## ASSESSMENT REPORT

### s75W Modification - Hoxton Park (Len Waters) Industrial Estate Bridge Access and Residual Lot Layout

Figure 3: Proposed Hoxton Park (Len Waters) Industrial Estate Layout

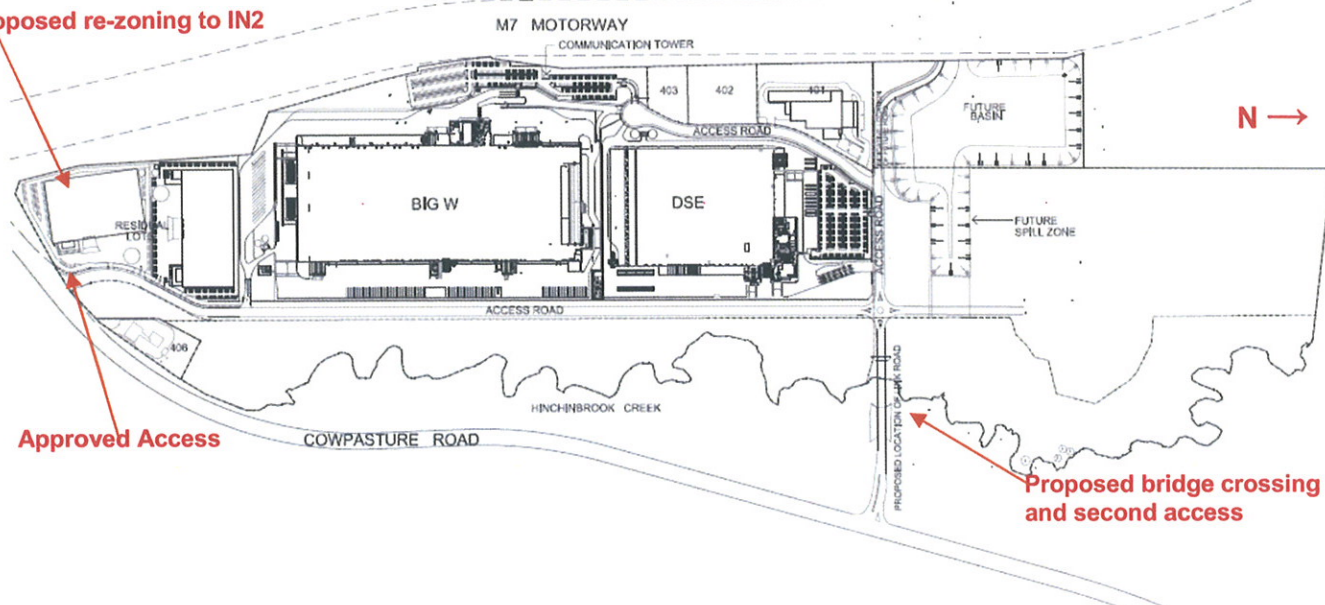
- allow for the development of a second access to the site off Cowpasture Road; and
- remove the stormwater basin located in the south west corner of the site, in order to facilitate the development of the area as light industrial (see Figure 3).

The revised design proposed the construction of an underground network of pipes and box culverts in lieu of a stormwater detention basin or an open channel. Due to this design change, the land set aside for the detention basin is no longer required; and therefore through modifications to the Concept Plan, Mirvac proposes to rezone the south-western corner of the site from SP2 Infrastructure to IN2 Light Industrial to maximize the employment generating potential of the land (see Figure 3) (the legal advice sought by the Department regarding the proposed re-zoning, is discussed in Section 3 of this report).

Currently the south west corner of the site is zoned SP2 for the provision of a stormwater detention basin. As this basin is no longer required, Mirvac is seeking to develop this area as industrial. However, the industrial use is not permitted in this location due to the SP2 zoning. Therefore, Mirvac is seeking to rezone this area as IN1, via a modification to the Concept Plan approval, to accommodate the future development of the area for industrial purposes.

As a result, the Department considers that it would be sufficient to amend the Concept Plan and Stage 1 Infrastructure Project to extend the building pads of the residual lots into the SP2 zone, to allow Mirvac to develop the area for industrial purposes. As such, Mirvac has submitted revised plans extending the area of the residual lots into the area previously approved as a stormwater detention basin, to allow for the future development of the area as IN2.

Figure 4: Proposed Intersection at Cowpasture Road

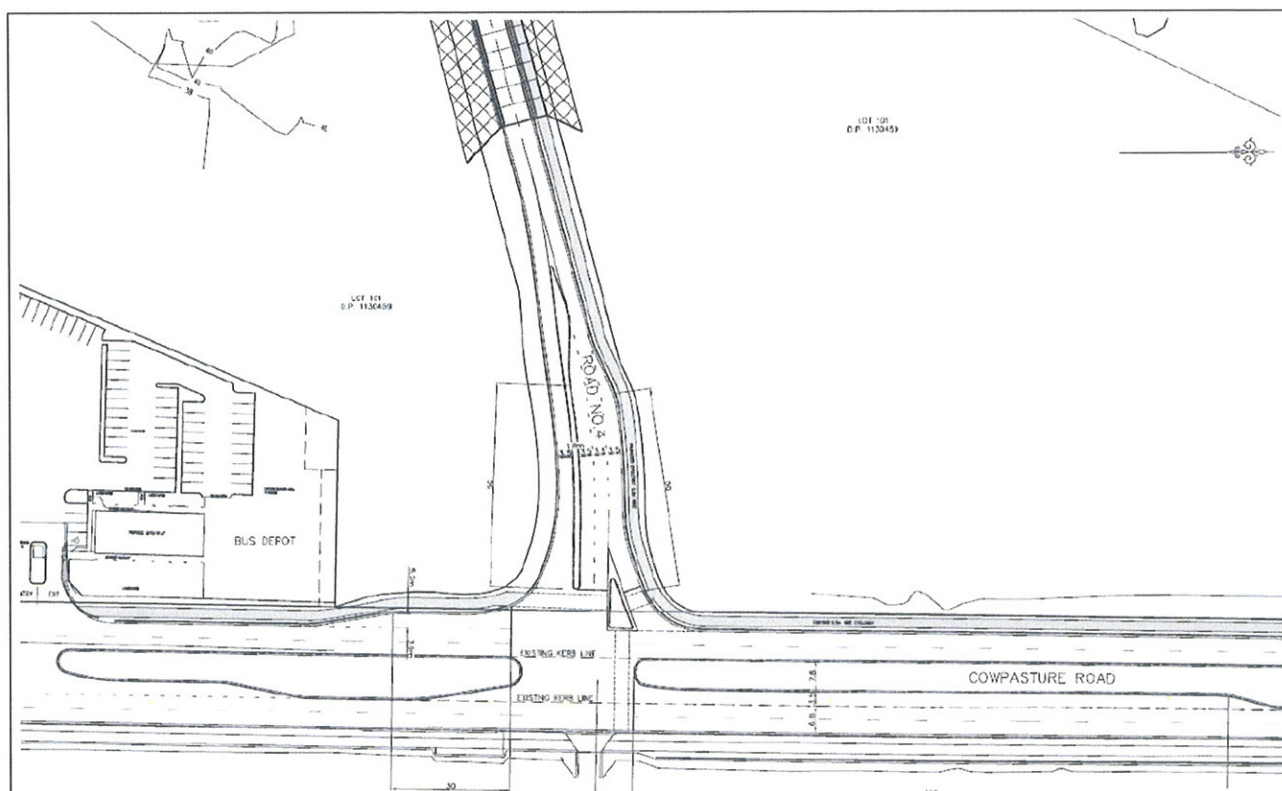
The **RTA** did not object to the proposed modification, however recommended a number of conditions to the proposed signalised intersection, including layout; design; the requirement for the developer to enter into a Works Authorisation Deed; and stormwater discharge from the site.

*Figure 5: Proposed Bridge Design (Photomontage)*

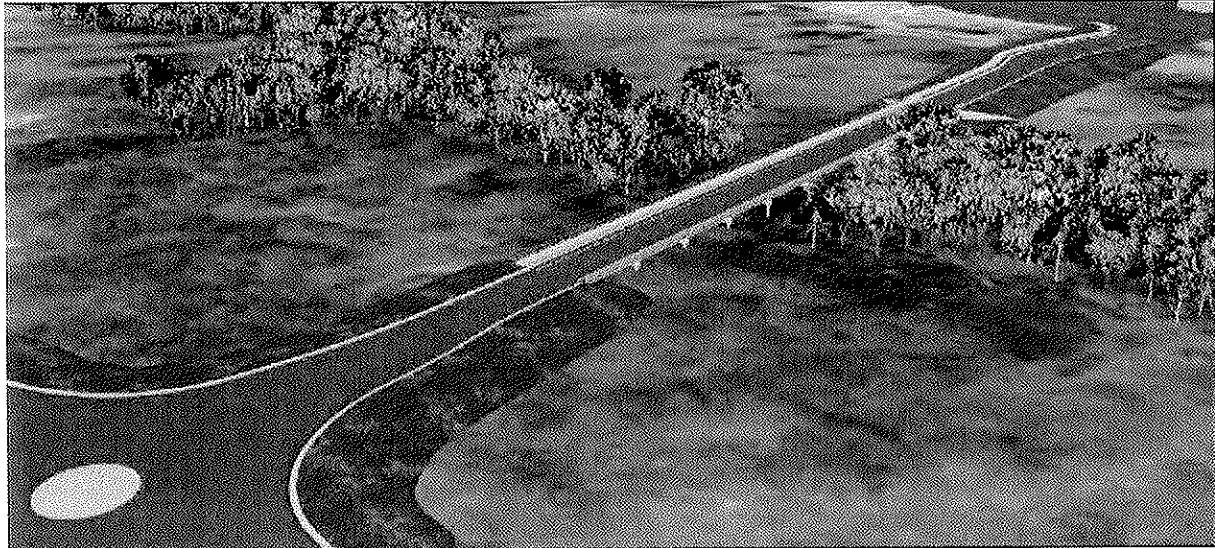
The access would include the construction of a bridge link across Hinchinbrook Creek, in accordance with condition 8 of the Concept Plan approval (see Figures 4 & 5). The bridge is proposed to be a proprietary "M-Lock" system and will span 72m across Hinchinbrook Creek. The key design parameters include:

- six equal spans of 12m in length;
- 9.6m clear width between traffic barriers;
- traffic barriers to RTA specifications;
- deck drainage by scuppers into the flood plain below; and
- the bridge deck to be supported on 585mm diameter precast concrete piles.

NOW raised concerns with the width of the bridge crossing and made a number of recommendations regarding Hinchinbrook Creek riparian corridor. These recommendations included: amending the design of the bridge to allow at least a 50m riparian corridor on either side of the creek; that the piers are located outside the channels and the banks of the creek; that the culverts have a naturalised base to enhance fauna movement. NOW also advised that the revegetation activities proposed to the north of the bridge crossing should not be undertaken in High Flood Risk areas, as was indicated in the letter from Council which was included in the EA.

Mirvac argue that constructing the bridge to span the entire riparian corridor is not feasible. It is further argued that the proposed design and offset allows the bridge to maintain connectivity of riparian vegetation and that the locations of the bridge piers were selected to ensure that piers were as far removed from the creek as possible. Mirvac also confirmed that in areas indicated as 'High Flood Risk' only regeneration activities would occur as recommended by NOW. The Department considers this approach acceptable in maintaining the connectivity of the riparian corridor.
